Modifications to the Harbourside Shopping Centre Redevelopment

State Significant Development Modification Assessment Report (SSD-7874-MOD-6, SSD-49295711-MOD-8 & SSD-49653211-MOD-1)

May 2026

Figure 5 | Indicative intersection configuration. (Source: JMT Consulting).

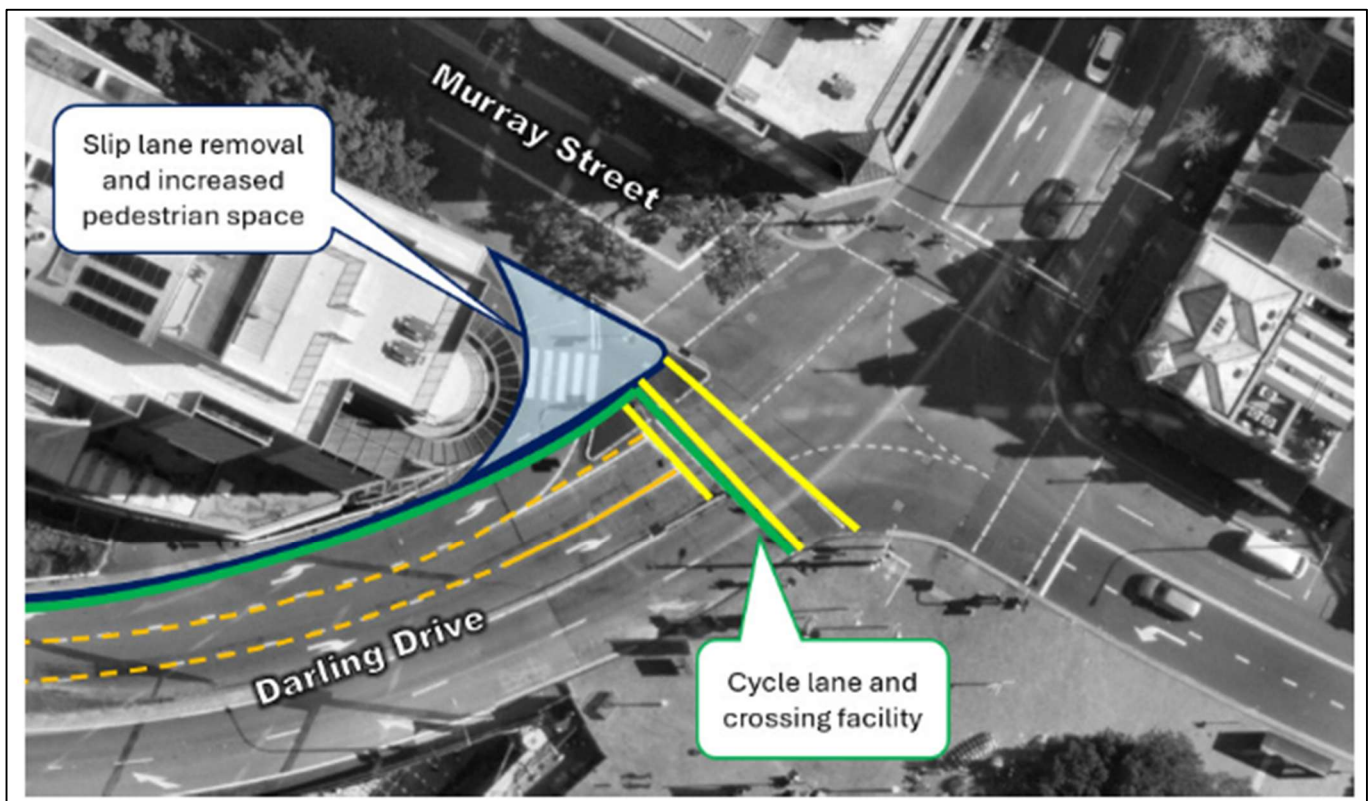
The Department sought independent transport advice to assess whether the measures initially proposed by the Applicant adequately addressed pedestrian connectivity and safety impacts from the removal of the North Bridge. The independent advice found that the removal of the bridge would result in additional pedestrian demand to cross Murray Street, which has been identified as a safety risk. Accordingly, should approval be granted for the bridge's removal, an upgrade to the Murray Street crossing would be required to mitigate these impacts. The independent expert recommended an alternative configuration (**Figure 5**) involving:

- removal of the left-turn slip lane on Murray Street
- reconfiguration of the intersection with a larger grade separated space to improve pedestrian and cyclist safety

In response, the Applicant agreed to a condition requiring it to design and deliver the recommended upgrades. Council and PMNSW supported this approach, subject to the detailed design being

The Department therefore considers the removal of the North Bridge to be acceptable, subject to conditions requiring the Applicant to:

- design and deliver the Darling Drive / Murray Street intersection upgrade in consultation with PMNSW, TfNSW and Council
- coordinate the design with the Darling Drive cycleway upgrade required under Condition B22 of SSD-49653211
- secure delivery of the works through a bond and deed arrangement with PMNSW
